CIS Building – Manchester

DAS ADDENDUM | 24 MARCH 2020
10246-SHP-RP-DAS ADDENDUM | REV 01

Introduction

The purpose of this document is to provide additional information to address the specific comments and points of clarification raised by internal Manchester City Council consultees during the determination period. The document does not change any of the submitted documents or the information within them.

Lowered Cills Elevation Study

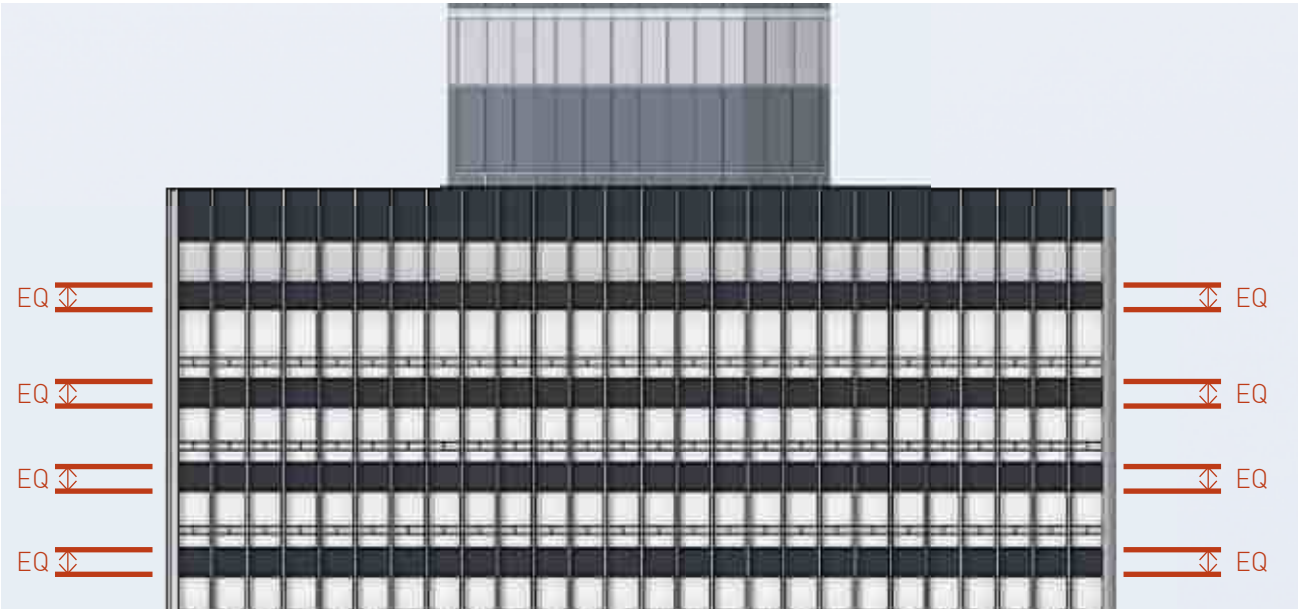
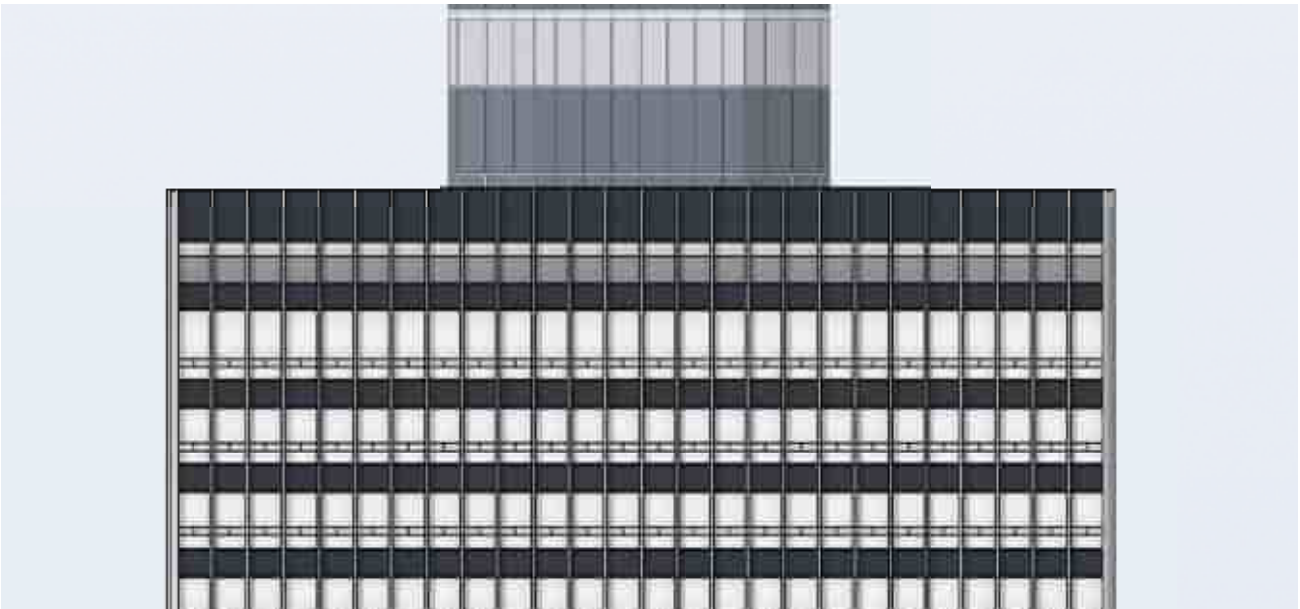
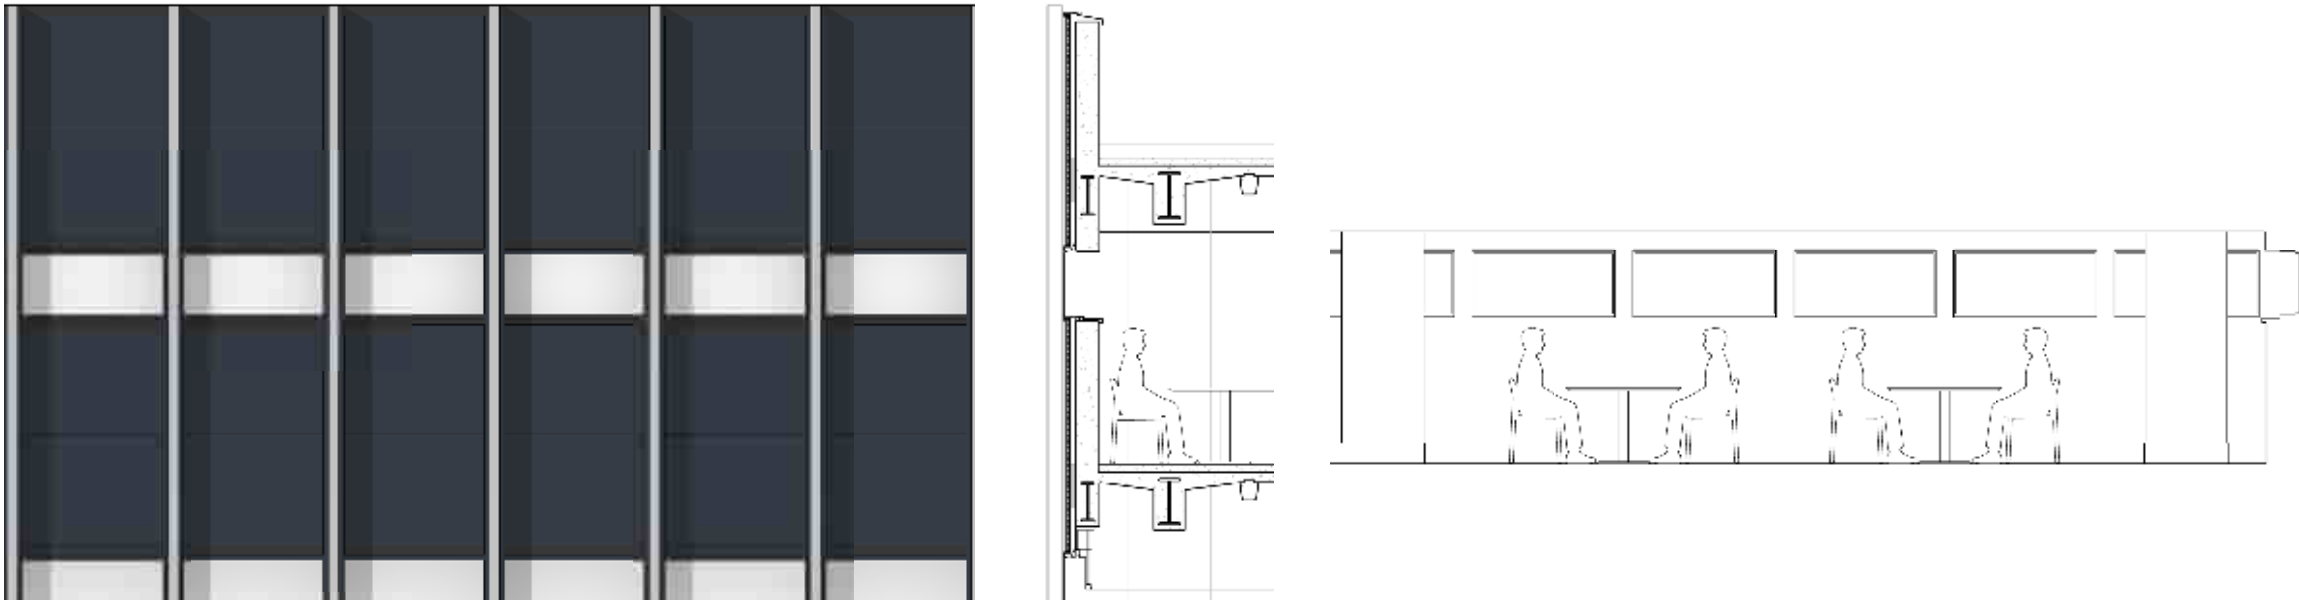
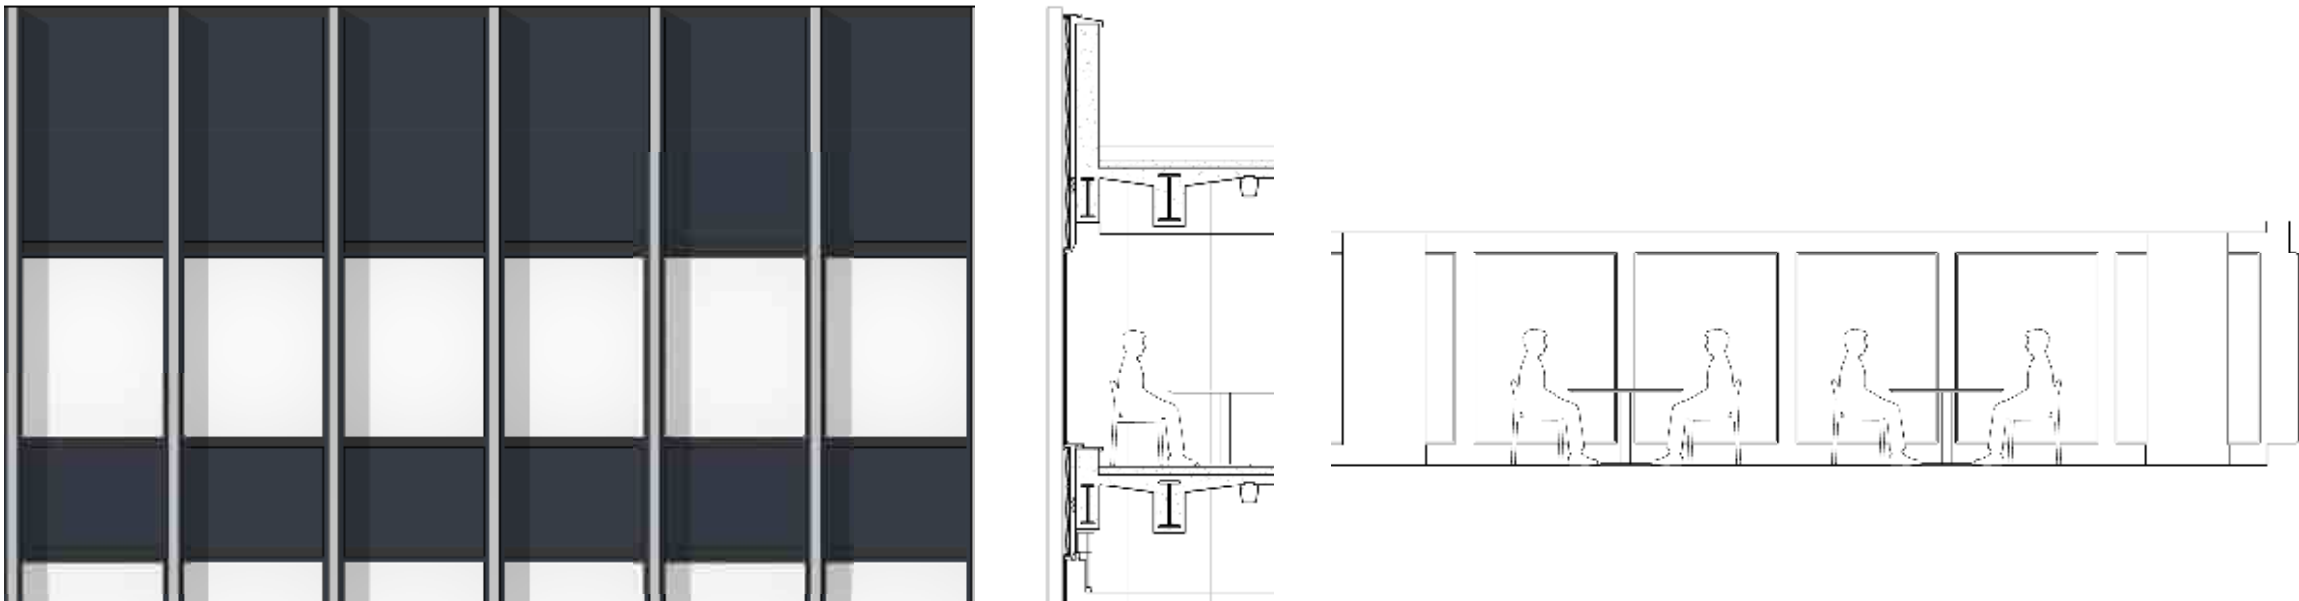
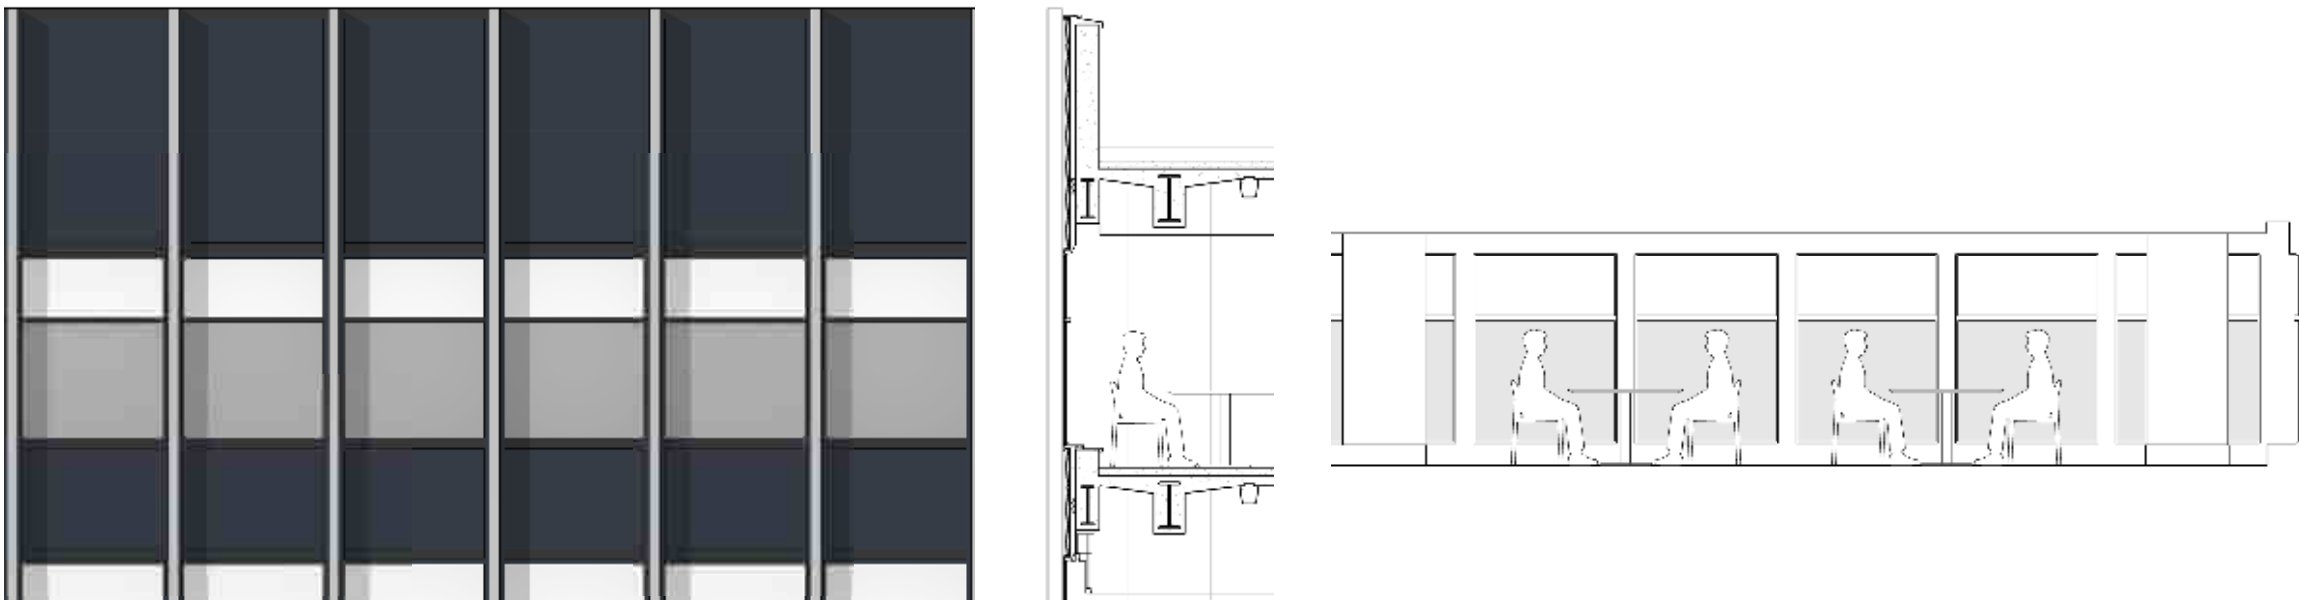
- › Lowering the cills of L25 has the potential to bring the space into use as an office floor plate, however this has an effect on the aesthetic of the building ‘crown’. This has been reviewed in terms of other possible approaches, as described below.

- › Importantly, it is also felt the visual effect internally would be quite unusual, as demonstrated by the adjacent internal elevations.
- › In conclusion, based on the above commentary, it is felt the current proposal is an appropriate approach in terms of balancing the internal environment and the external characteristics
